Title-Sujet: Construction – Wabasca-Desmarais Detachment	
Solicitation No. - No. de l'invitation 201804138	Date Jan 31, 2018
Client Reference No. - No. De Référence du Client 201804138	Amend No.- No. du modif. 005
GETS Reference No. - No. de Référence de SEAG 201804138	
Solicitation Closes –L'invitation prend fin at - à 14 :00 ET on - le Feb. 6th, 2018	
F.O.B. - F.A.B. Destination	
Address Enquiries to: - Adresser toutes questions à: jordan.mckenna@rcmp-grc.gc.ca	
Telephone No. - No de telephone 613.843.5518	Fax No. - N° de FAX:
Destination of Goods, Services, and Construction: Destinations des biens, services et construction:	
Delivery Required - Livraison exigée:	Delivery Offered - Livraison proposée
Name and title of person authorized to sign on behalf of Vendor/Firm Nom et titre de la personne autorisée à signer au nom du fournisseur/de l'entrepreneur

Amendment #5 of Solicitation 201804138 has been issued to make changes to the Tender document

ADDENDUM No. 04

**GOVERNMENT OF CANADA
WABASCA-DESMARAIS GOVERNMENT BUILDING**

Drawing Title
**MAIN FLOOR
LIFE SAFETY PLAN**

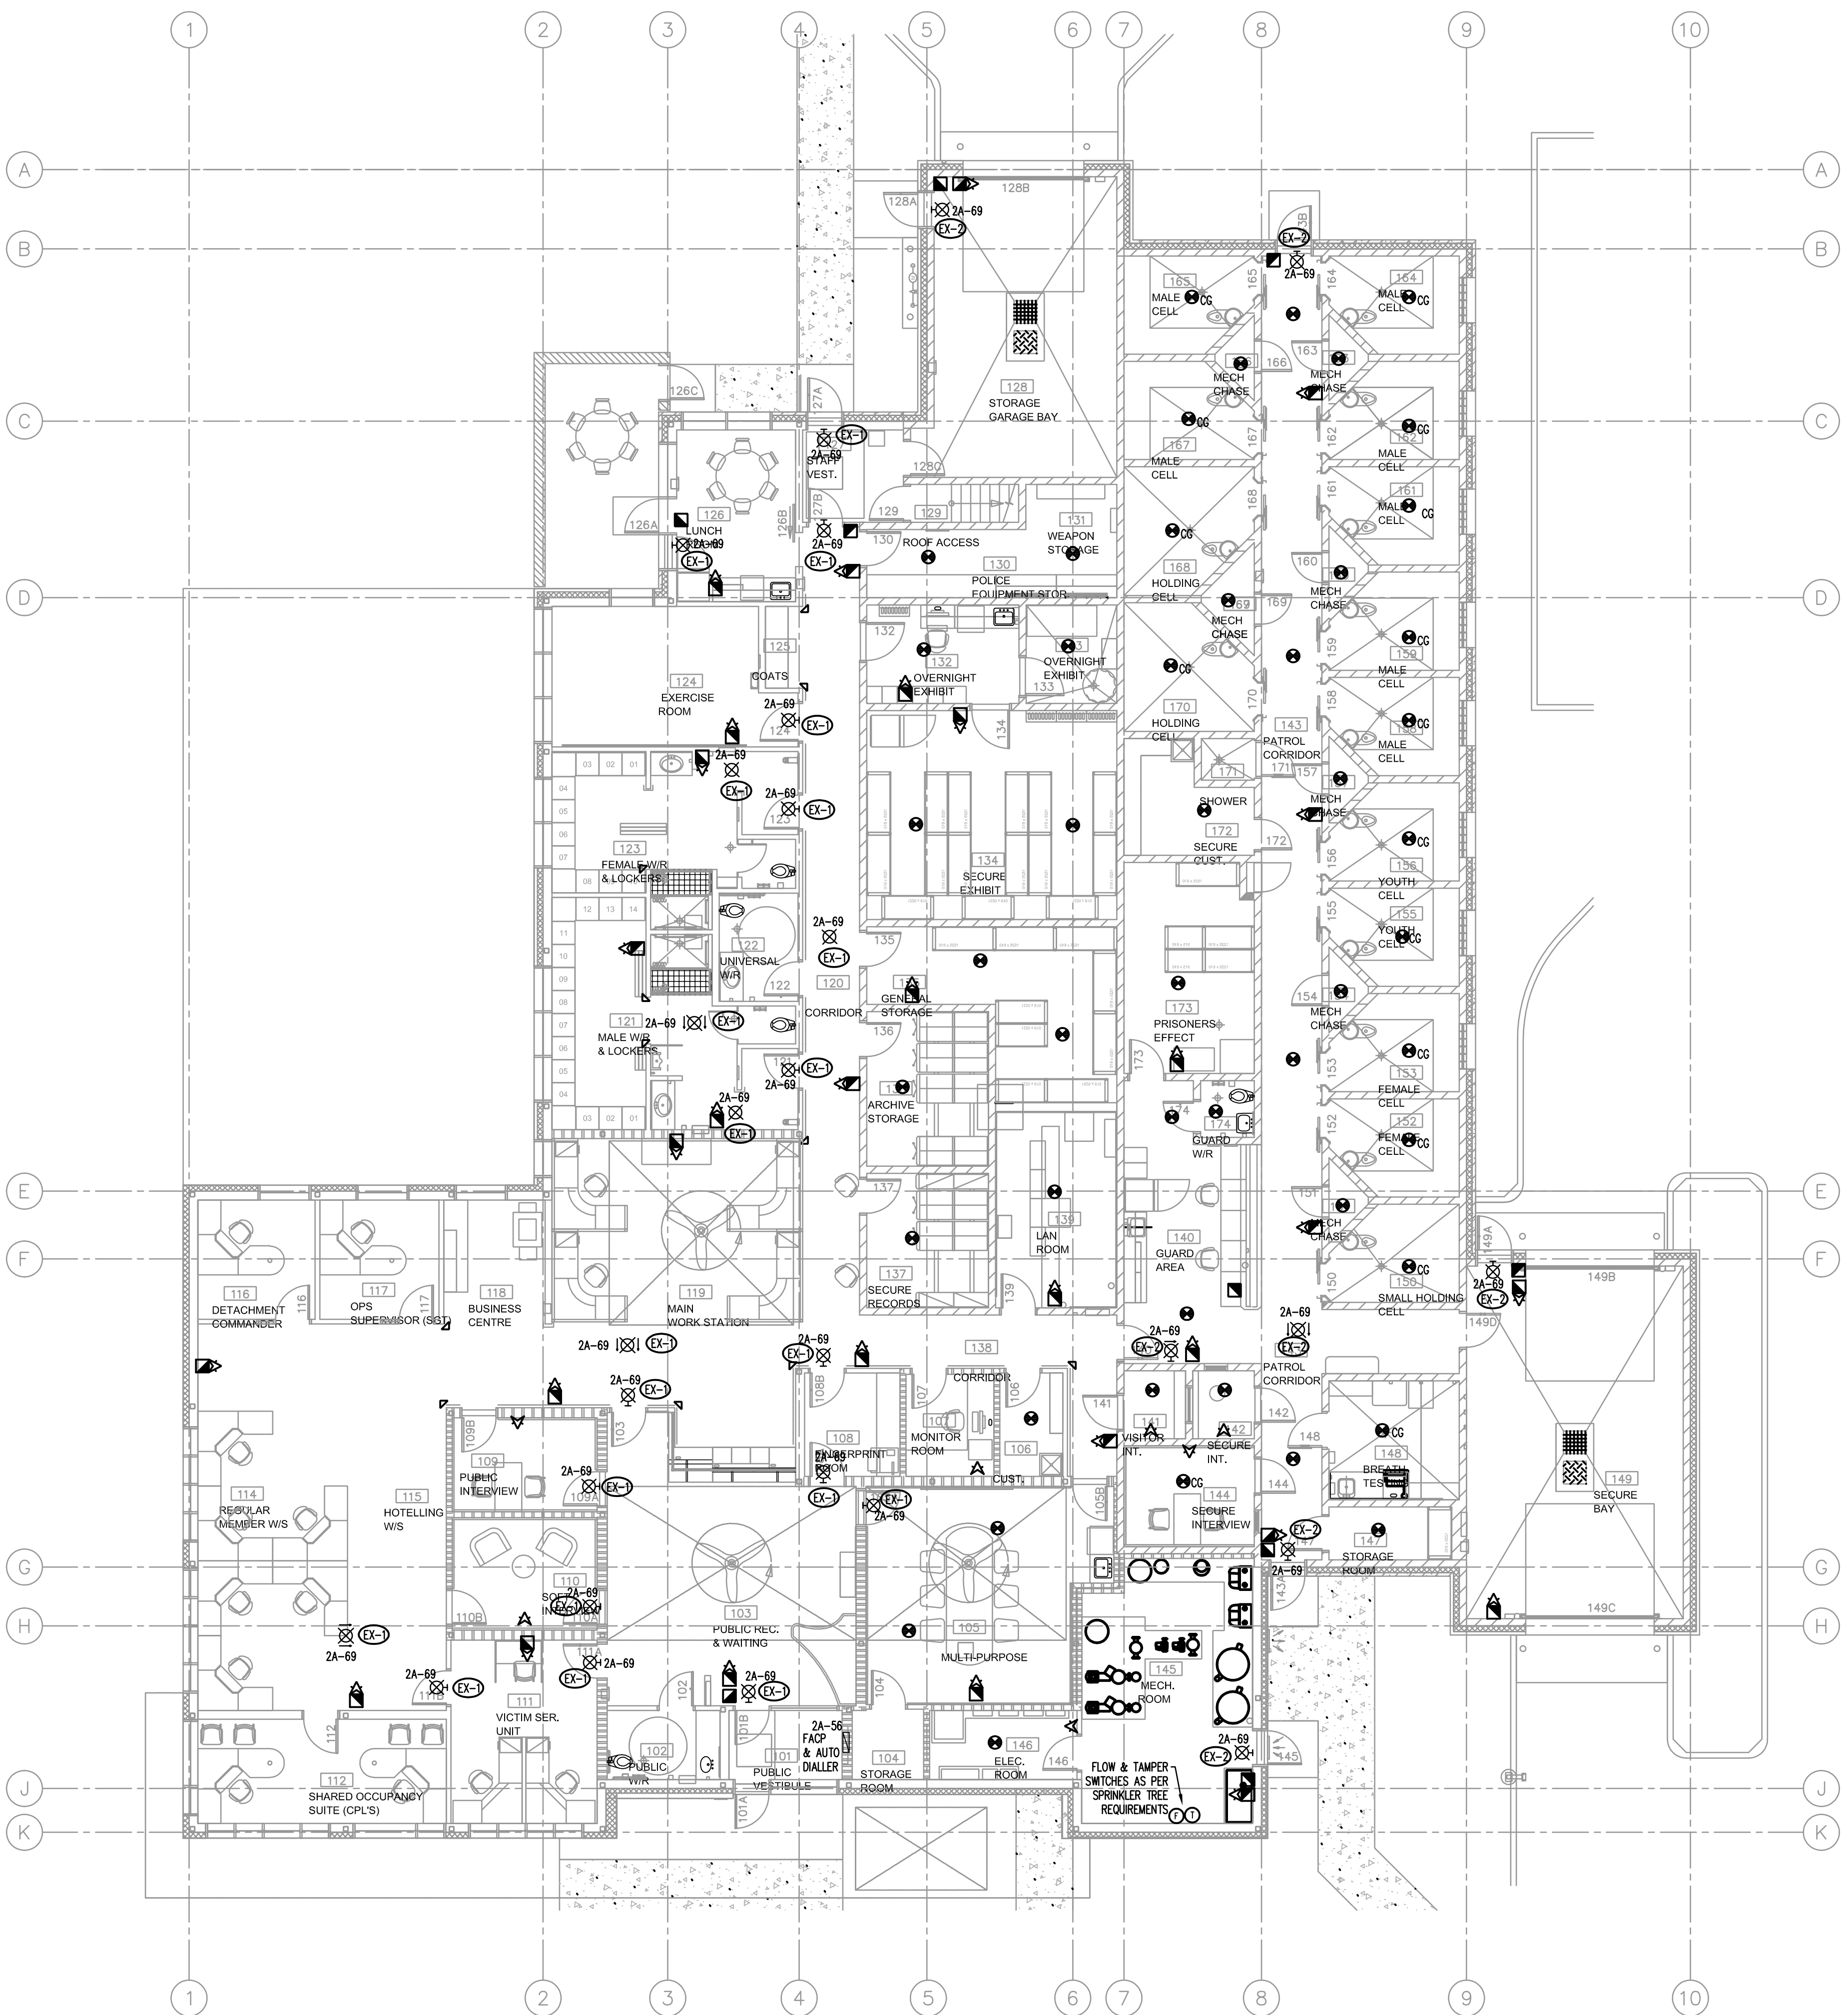
2. Drawing E4.0

REVISE: Drawing has been re-issued with this addendum to address alignment issues.
